Subject: V. C. Summer Nuclear Station Units 2 and 3  
Docket Numbers 52-027 and 52-028  
Combined License Application – Response to NRC  
Environmental Report (ER) Requests for Additional Information  
(RAI): GW-3 Revision 1

**VCSNS UNITS 2 and 3  
Environmental Report Review  
Response to NRC Requests for Additional Information**

**NRC RAI Number:**       GW-3       **Revision:**   1

Figure 2.3-34 Plan View of Subsurface Groundwater Contaminant Pathways for Units 2 and 3 (All elevations are with reference to the NAVD88 datum) to the Unnamed Creeks (saprolite/shallow bedrock zone)

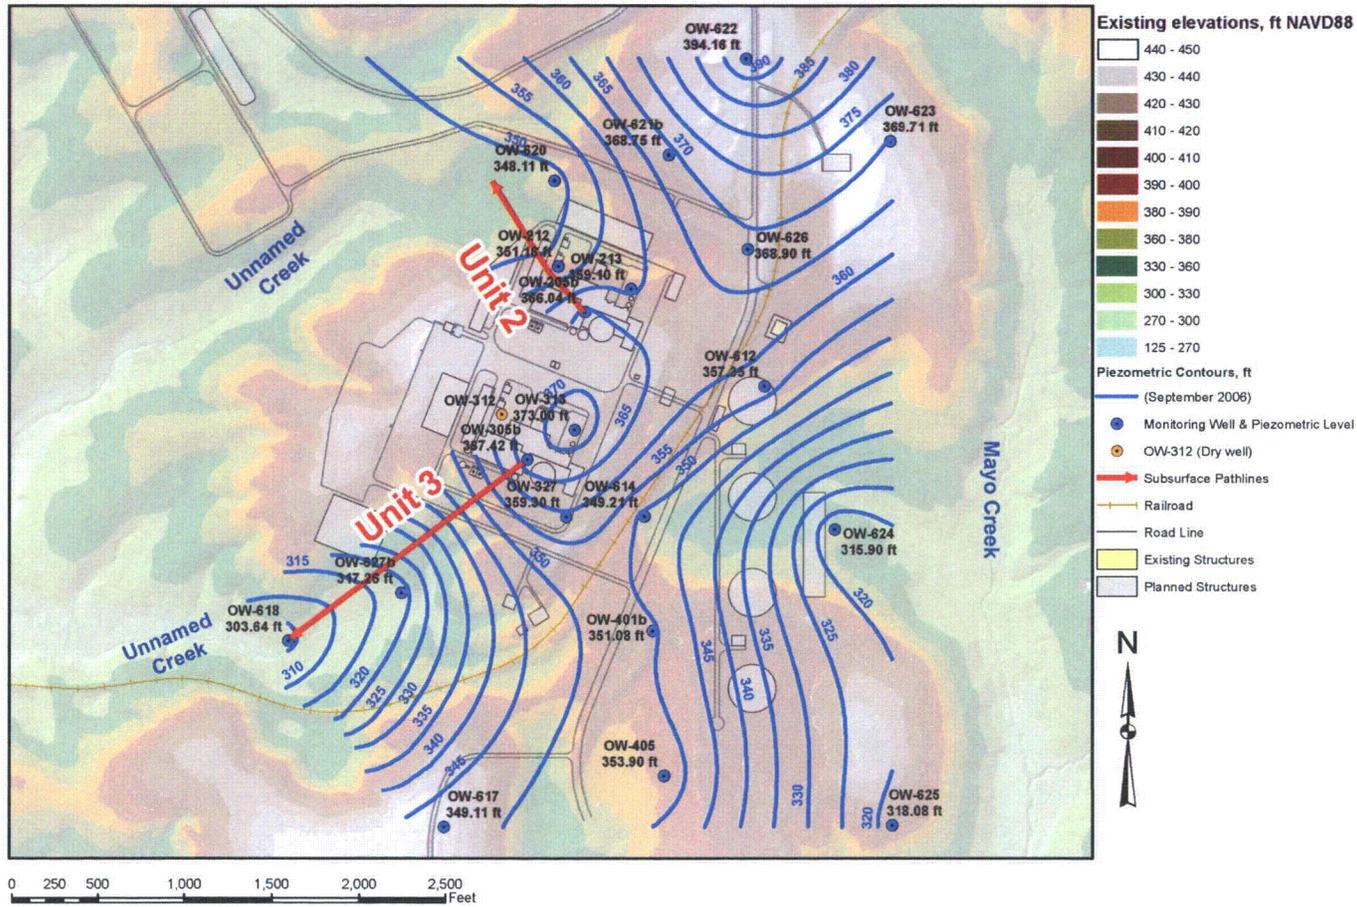
Evaluate eastern groundwater pathways from the proposed new units in the saprolite/shallow bedrock zone and deep bedrock zone toward possible receptors (e.g. Mayo Creek and wells). Also, evaluate possible westward pathways from the proposed new units in the deep-bedrock pathway (the western pathway in the saprolite/shallow bedrock zone is the only pathway described in the ER).

Eastern groundwater pathways from the proposed new units in the saprolite/shallow bedrock and deep bedrock zones have been evaluated. Westward pathways from the proposed new units in the deep bedrock zone have also been evaluated. The results of these evaluations are presented in the attached proposed revisions to ER Subsection 2.3.1.2.3.

The Units 2 and 3 ~~site is~~ would be located on a ridgetop. Piezometric contour maps developed from piezometric levels measured for one year from June 2006 through June 2007 indicate that groundwater flows in all directions from the ridgetop. Drainage swales are present to the northwest, southwest, and east of the site as can be seen from the topographic map in Figure 2.3-2. These swales drain to tributaries that eventually lead to

The primary and most plausible groundwater pathway from the Units 2 and 3 auxiliary buildings is through the saprolite/shallow bedrock zone to the nearby unnamed creeks, one to the north-northwest of Unit 2 and the other to the south-southwest of Unit 3.

$$v = \frac{K}{n_e} \frac{dh}{dx} = \frac{1.7 \text{ ft/day}}{0.18} (-0.032 \text{ ft/ft}) = 0.30 \text{ ft/day} \cong 110 \text{ ft/yr}$$

$$t = \frac{L}{v} = \frac{850 \text{ ft}}{110 \text{ ft/yr}} \cong 7.7 \text{ yrs}$$

This same methodology was also used for calculating the groundwater travel time from Unit 3. ~~The differences are at~~ At Unit 3, the horizontal hydraulic gradient was calculated to be ~~0.0369~~ -0.038 ft/ft (Table 2.3-25) and the straight-line distance from the auxiliary building of Unit 3 to the nearest unnamed creek to the south-southwest is about L=1727 feet. The estimated travel time from Unit 3 to the unnamed creek ~~to the south-southwest~~ ~~was is~~ 29.35 13.3 years. Calculated travel times are summarized in Table 2.3-25.
